Subject: Duke Energy Corporation
Catawba Nuclear Station, Unit 2
Docket Number 50-414
Response to Request for Additional Information for
Revision of Unit 2 Reactor Coolant System Cold Leg
Elbow Tap Flow Coefficients

Reactor Coolant System Cold Leg Elbow Tap Coefficients
Attachment

Figure 1

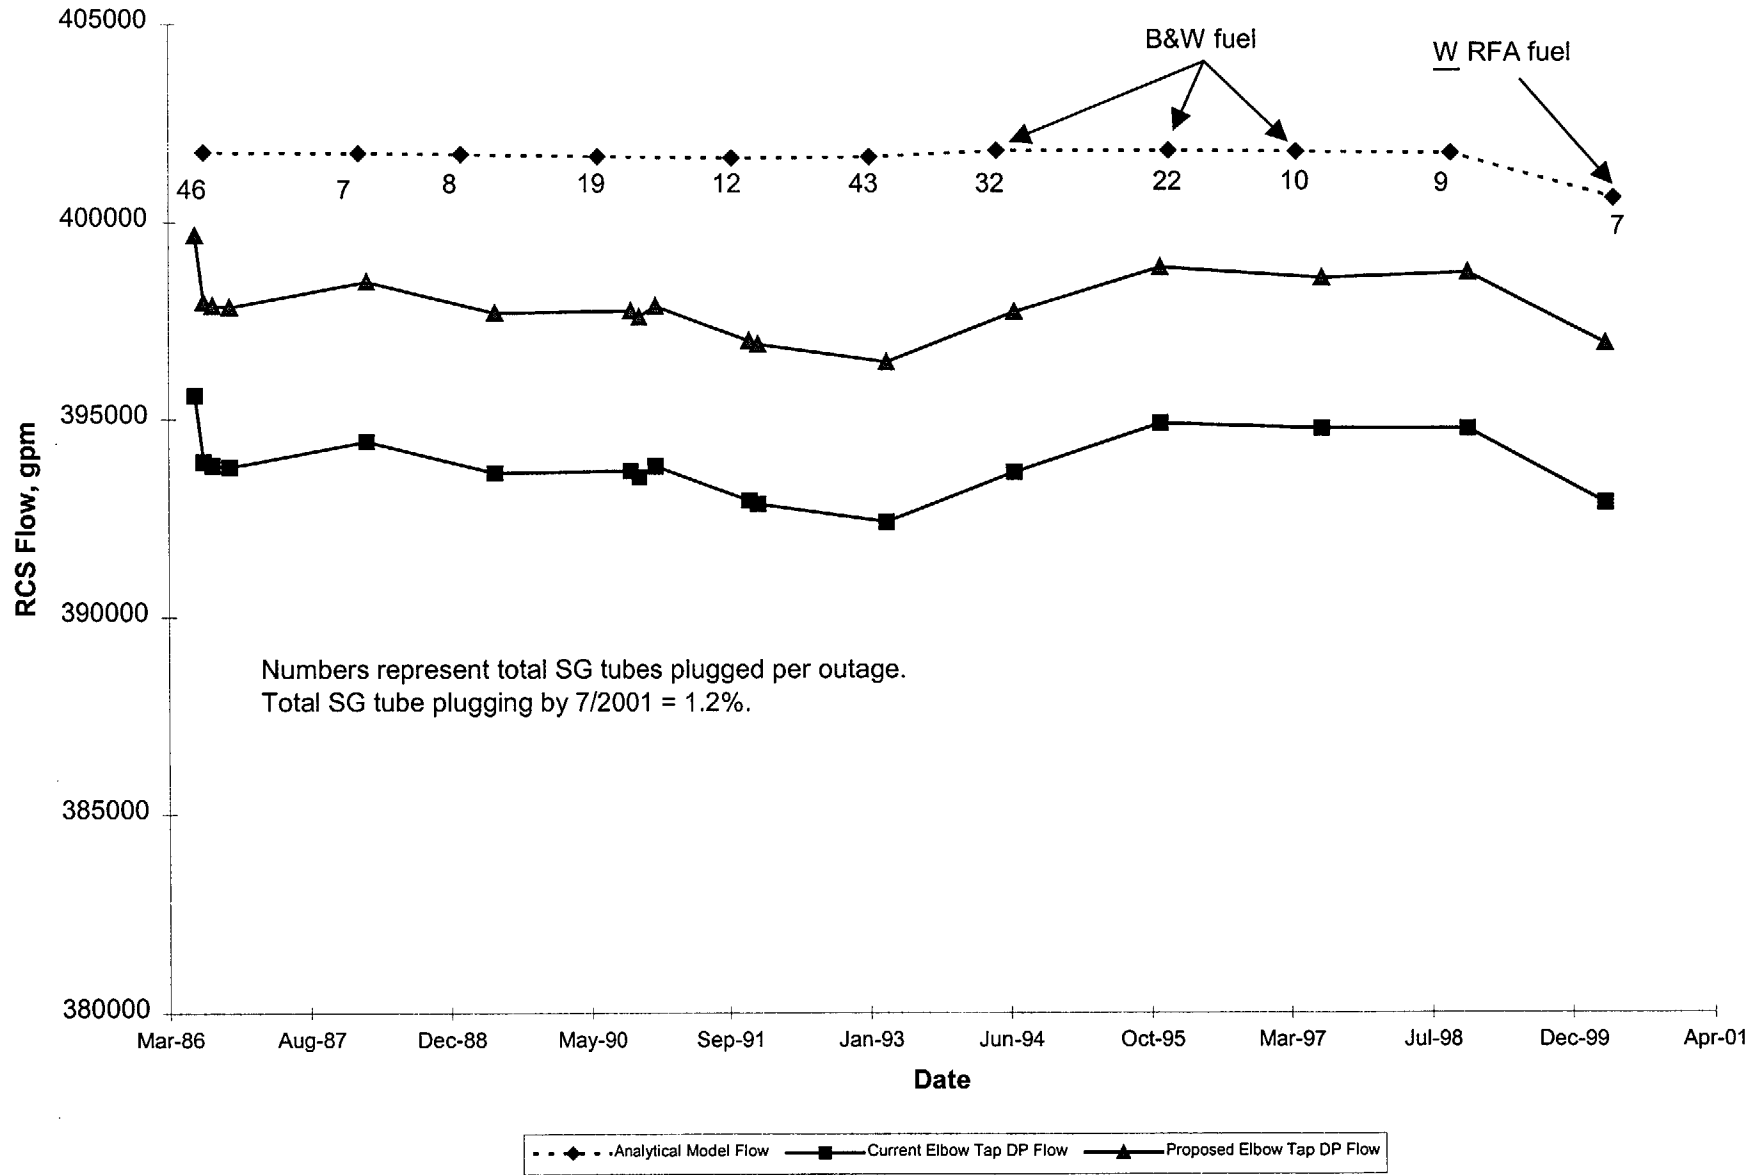
- 7) **Please provide information for tube plugging and fuel pressure drop changes that have occurred since 1993. Also provide information about the ability of your analytical flow model to predict the flow changes.**

8) Concerning Figure 1, please provide information to explain variations in the plant data versus the analytical flow model prediction.

Response: See attached Figures 1 through 3. Figure 1 shows the Catawba Unit 2 flow data from startup to present. Shown are the analytical model prediction of flow, the flow based on the current elbow tap flow coefficients, and the flow based on the proposed elbow tap flow coefficients. Also shown is the number of SG tubes plugged to the current total of 1.2%. The B&W and Westinghouse fuel transitions are also indicated. This data shows that flow at Catawba Unit 2 has changed very little until the recent introduction of Westinghouse fuel.

As shown in the Figures 1 and 3 the analytical flow model can predict flow changes quite well. However, the accuracy of any prediction is only as good as the input information to the model. As can be seen on Figures 1 & 3 the modeling changes for steam generator tube plugging is well understood and the model predicts the effects of tube plugging well compared to the actual measured data. There is an extensive history to draw on for this type of change and the effect it has on the reactor coolant flow. Other plant changes such as introduction of new fuel and steam generator replacement can be predicted well if the expected change in their pressure drops are accurately estimated. For example, on Figure 1 the flow increase prediction, using the analytical flow model, for the introduction of B&W fuel showed a much smaller increase than the measured data as shown in the elbow tap ΔP flow curve. This was largely the result of an under prediction of the pressure drop decrease across the core region when the new fuel was introduced into the core. This is generally by

Response: The analytical flow model is a prediction of flow based on pressure drop data and first principle calculations. The elbow tap data is plant measured data produced by the elbow tap pressure transmitters and the cold leg density calculated from the cold leg temperature indications and corrected pressurizer pressure. The elbow tap method of measuring flow eliminates the large negative impacts of the hot leg streaming but, the indication is also affected by smaller affects such as transmitter and rack component drift and streaming effects in the cold leg and it's effect on the density calculation. These effects result in small variations in the elbow tap ΔP flow indication which will not be present in the analytical flow model prediction of flow. In addition, as discussed in the response to question 7, when component pressure drop changes are under or over predicted in the analytical flow model the result will produce differences between the model and the actual measured flow. Figures 1 through 3 show that the elbow tap ΔP s are very repeatable and trend the effects of steam generator tube plugging and other RCS changes with limited variability, which is generally attributable to ΔP transmitter drift and small cold leg streaming effects.

Figure 3

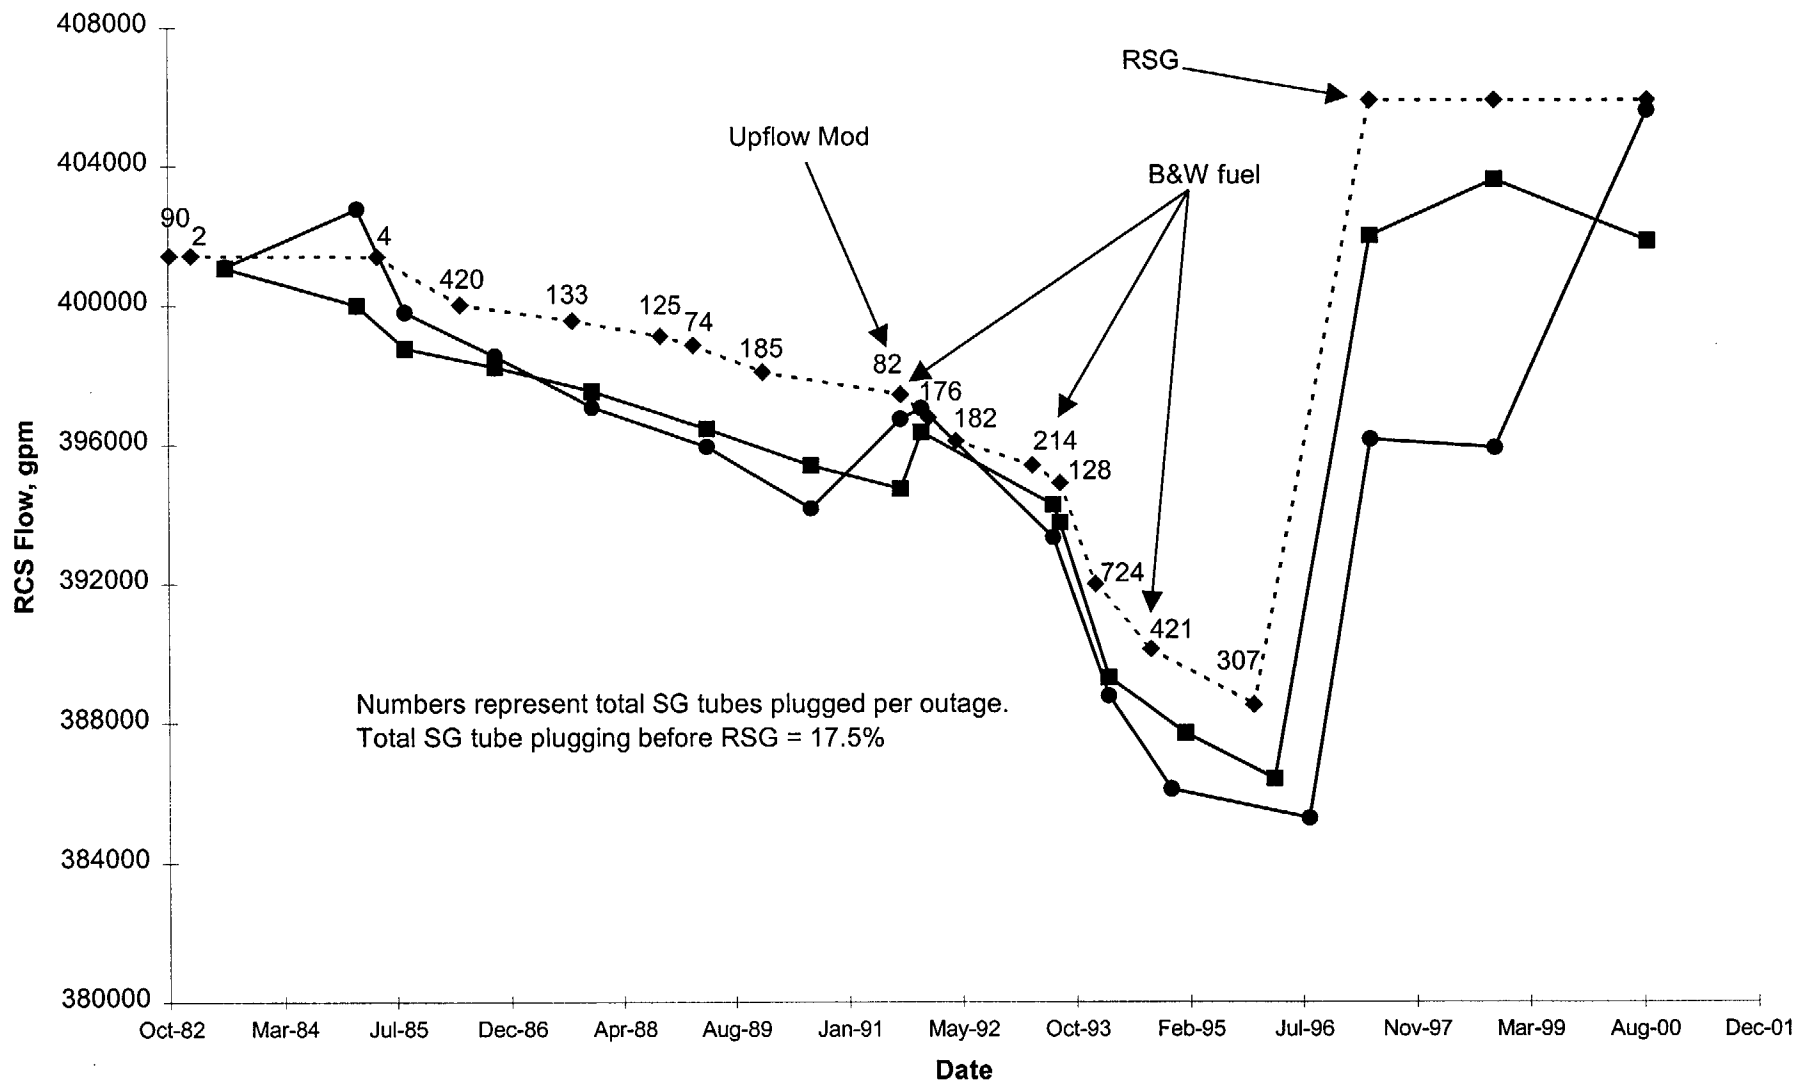
10) Concerning Figure 3, please provide information which would explain the increase in the flow difference between the elbow tap determined flow and the calorimetric determined flow at the time of steam generator replacement.

11) Please provide information explaining how the effects of the up-flow modification, B&W fuel, and steam generator tube plugging affect the January 1992 flow value given on Figure 3.

Figure 3 shows the McGuire Unit 1 data. The data trends show how significant hydraulic changes such as large SG tube plugging (17.5%) and SG replacement (RSG) change the plant flow data based on elbow taps and the analytical model prediction.

Response: The increase in the difference between the elbow tap measured flow and the calorimetric calculated flow following the replacement of the steam generators at McGuire Unit 1 is an increase in the streaming effect. The maximum difference in the hottest to coldest hot leg RTDs was $\approx 11.6^\circ\text{F}$ during the period prior to the replacement of the steam generators. Following replacement of the steam generators, a maximum difference in the hottest to coldest hot leg RTDs was found to be $\approx 13.0^\circ\text{F}$. McGuire Unit 1 has not been significantly impacted by the streaming effect prior to replacing the steam generators. However, it appears that the new steam generators with their reduced hydraulic resistance have allowed the streaming effect to increase slightly. This increase in the hot leg streaming is the reason that the calorimetric flow did not increase in direct proportion to the elbow tap indicated flow following steam generator replacement. Also, note that Figure 3 has been updated to include an additional data point for September 2000. This data point was inadvertently excluded from the Figure 3 provided during the July 9, 2001 phone call. The additional

data point for the September 2000 calorimetric shows a large increase in the calculated flow from the previous calorimetric surveillance. This jump in flow results from a correction to the calorimetric calculation. The reactor coolant pump power was inadvertently subtracted in the previous calorimetrics instead of added, as it should have been.

Response: The McGuire EOC-7 refueling outage was performed in September 1991. During this outage three changes in the hydraulics of the RCS were made, the reactor vessel downcomer up-flow modification, the first batch of B&W fuel, and 82 steam generator tubes were plugged. The up-flow modification changed the flow fractions in the reactor vessel downcomer and through the core slightly increasing the pressure drops in these regions of the reactor coolant system. The analytical flow model predicted a decrease in flow of approximately 400 gpm (or $\approx 0.1\%$ flow) due to this change.

Steam generator tube plugging of 82 tubes also occurred during this refueling outage. The analytical flow model predicted a decrease in flow of approximately 380 gpm (or $\approx 0.1\%$ flow) due to this change.

The introduction of the first batch of B&W fuel was expected to increase flow due to a decreased overall fuel pressure drop. The analytical flow model predicted an increase in flow of approximately 170 gpm (or $\approx 0.05\%$ flow) due to this change.

The sum total of these changes results in a prediction of an overall flow decrease of approximately 610 gpm (or $\approx 0.15\%$ flow). However, the elbow tap flow result indicates that a net flow increase of $\approx 0.40\%$ flow was realized due to the new fuel. The difference between these flows is the under predicted pressure drop estimates used in the analytical flow model as described in the response to question 7. This resulted in an analytical flow model calculated overall flow decrease when the measured elbow tap flow indicated a overall flow increase.
